Manitou RUE & VAR PLN51687 RUE & VAR

Staff Report

Project Manitou RUE & VAR
File No. PLN51687 RUE (master file) & PLN51687 VAR
Date January 28, 2020
To City of Bainbridge Island Hearing Examiner
Project Manager Annie Hillier, Associate Planner

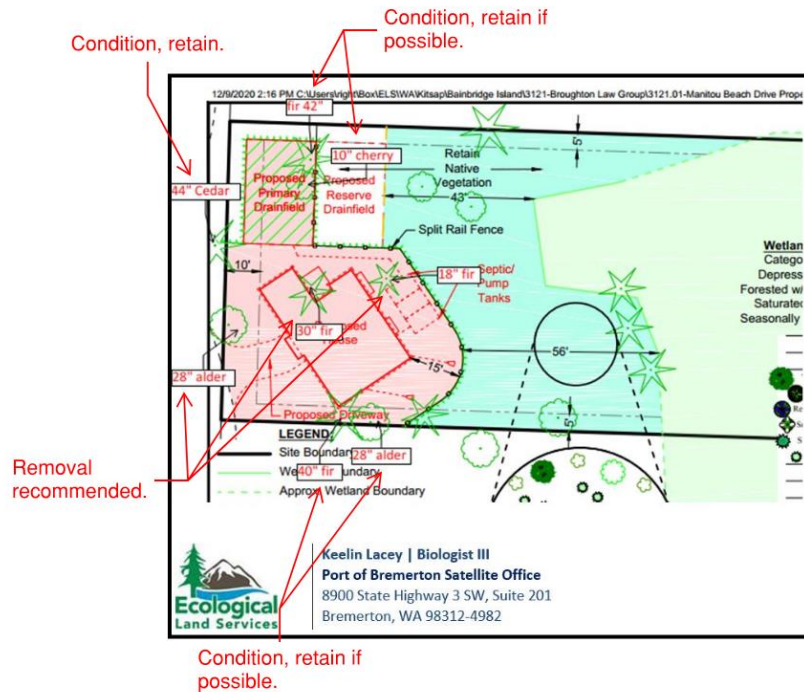
Agency:	Action:
Fire District	Approved, no conditions.
City Development Engineering	Approved with conditions (Exhibit 16)
Health District	Completed, no determination until building site application received (Exhibit 18)
City Arborist	The City Arborist reviewed the proposal in response to the public concerns raised about tree removal on the site and consistent with RUE review criteria #4, the proposed impact to the critical area is the minimum necessary to allow reasonable use of the property. The City Arborist's comments (Exhibit 17) indicate that while at least three significant trees require removal, it is possible for another five to be retained, depicted below.

The following conditions are recommended as a result of the City Arborist's comments (Condition 4):

- The 44" cedar along the west lot line must be retained and have its root zone protected to the greatest extent possible during construction.
- Consideration shall be given to retaining the 40" fir and 28" alder along the south lot line by adjusting the site plan to accommodate a 10' radius from the base of the trees for a tree protection area. If this is practically infeasible or will result in an increase in wetland buffer impacts, then this shall be documented with the building permit submittal for City review and acceptance.

Figure 4 – Mitigation proposal

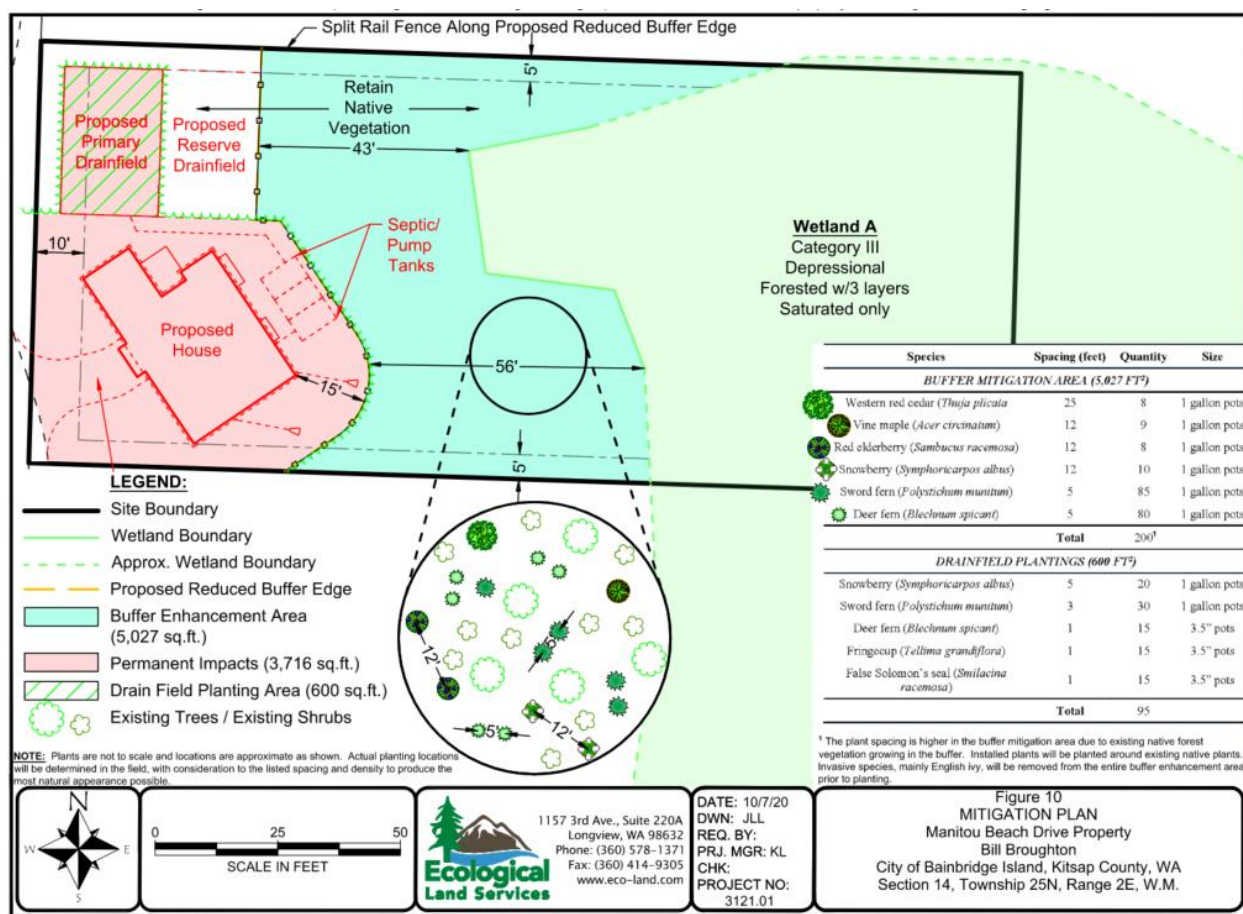
The mitigation plan goal is, "improve buffer functions to compensate for construction within the wetland buffer". The goal is not tied to a function of the buffer in its original condition, presumably because those functions have not been analyzed, as described below. Similarly, the objectives identified in the plan – to control invasive species, and to improve native plant cover and buffer function – are not tied to specific functions either (e.g. habitat, water quality, or otherwise).

Statements are made throughout the report about low species diversity and an abundance of invasive species within the wetland buffer. And while assumptions can be made about what these characteristics might mean for a particular function of the buffer, they are not tied to specific functions and staff is not in a position to make assumptions. The report also makes statements about increasing habitat function and the buffer's ability to screen from noise and light as a result of the mitigation proposal, but it is similarly unclear how the current conditions function to provide habitat and screening. Overall, there is a lack of data, either qualitative or quantitative, for staff to understand the functions and values of the original buffer. As such, the goals and objectives of the mitigation plan are too broad – essentially aiming to improve buffer

function without analyzing and identifying specific functions that will need to be improved as a result of impacts from development.

Staff recommends that a final mitigation plan be provided with the building permit application, in accordance with BIMC 16.20.180.G.3.b. The final mitigation plan shall include a quantitative or qualitative analysis, including supporting data, of buffer functions. Updated goals and objectives as a result of the original buffer functions shall also be provided. The City must agree that the final mitigation plan will result in no net loss of critical area function and value prior to building permit issuance. (Condition 5) Staff also notes that the type and amount of buffer enhancement proposed is typical for similar projects, so the Hearing Examiner may wish to consider the benefit of updating the mitigation plan if the outcome will remain the same. It is possible that this issue could be discussed further, and potentially resolved, at the project hearing.

Figure 8
WETLAND RATING FIGURE-1 KM OFFSET
 Manitou Beach Drive Property
 Bill Broughton
 City of Bainbridge Island, Kitsap County, WA
 Section 14, Township 25N, Range 2E, W.M.

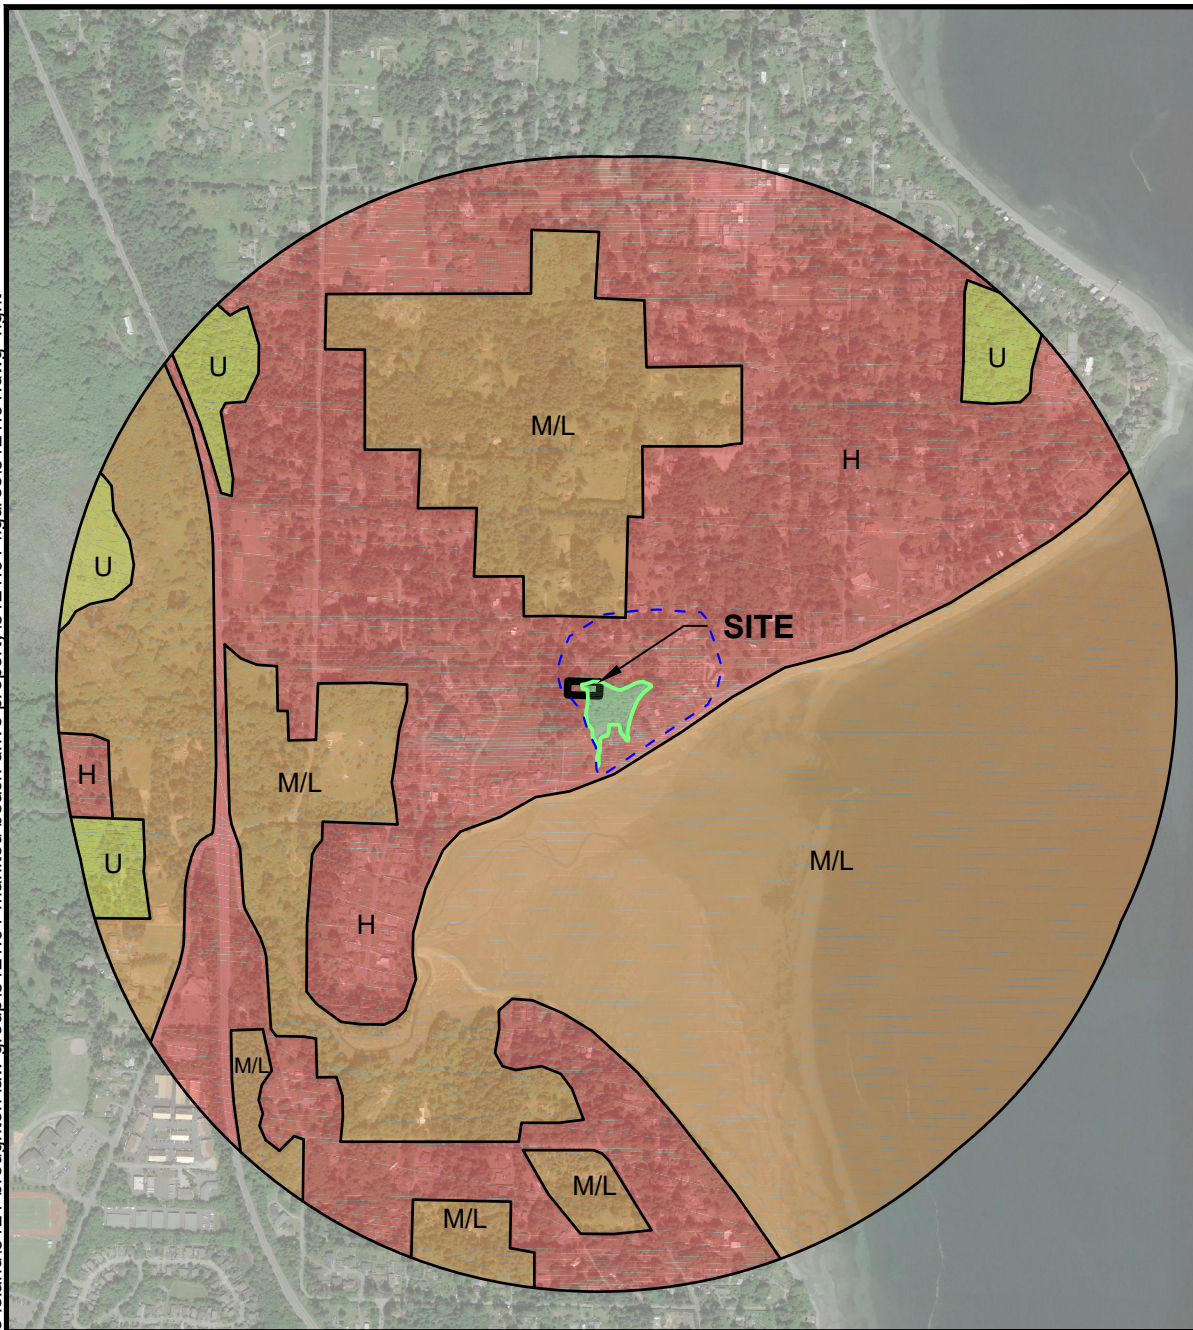
- The contributing basin on Figure 8 is incorrect, the area draining to this unit is smaller and to the east. Please revise.
- The report does not agree with the last rating form we received from ELS. The unit had category II rating previously. Please either change the rating or explain why the rating is different than the last time it was rated.

Please provide an updated wetland delineation report based on these comments.
